### **SUNDRY NOTICES AND REPORTS ON WELLS**

### BP - SJ Basin Proposed P&A Procedure 30-045-10042

Well Name: Kernaghan LS 1 (Kernaghan B 1)

### CONDITIONS OF APPROVAL

Figure 1: Current Well Schematic for the Kernaghan B1

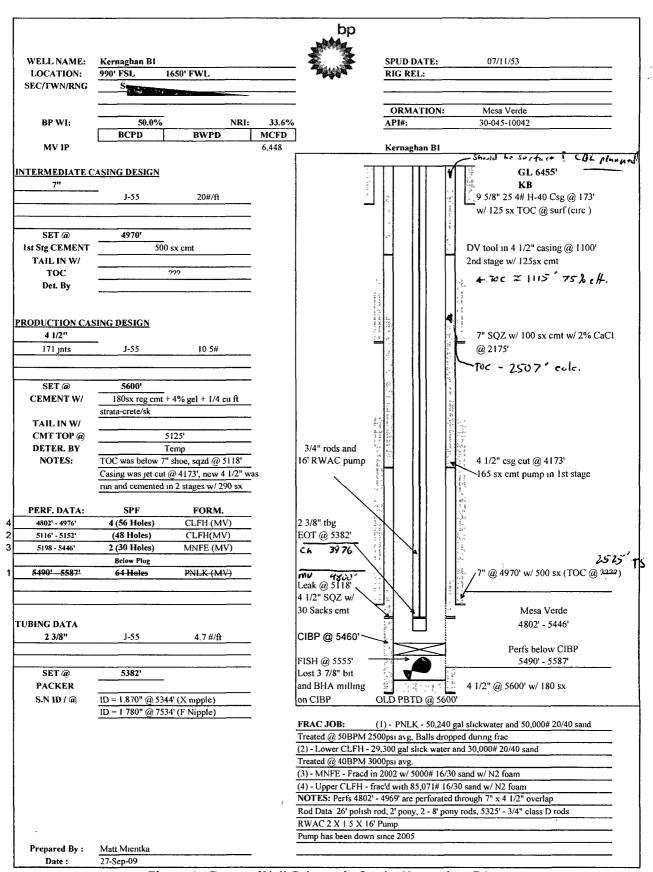
22301-19481 raside a itnot cement dursile the 4 /2

Necentario plus 755 - 655

inside 4 12" A oursile 7" Casing.
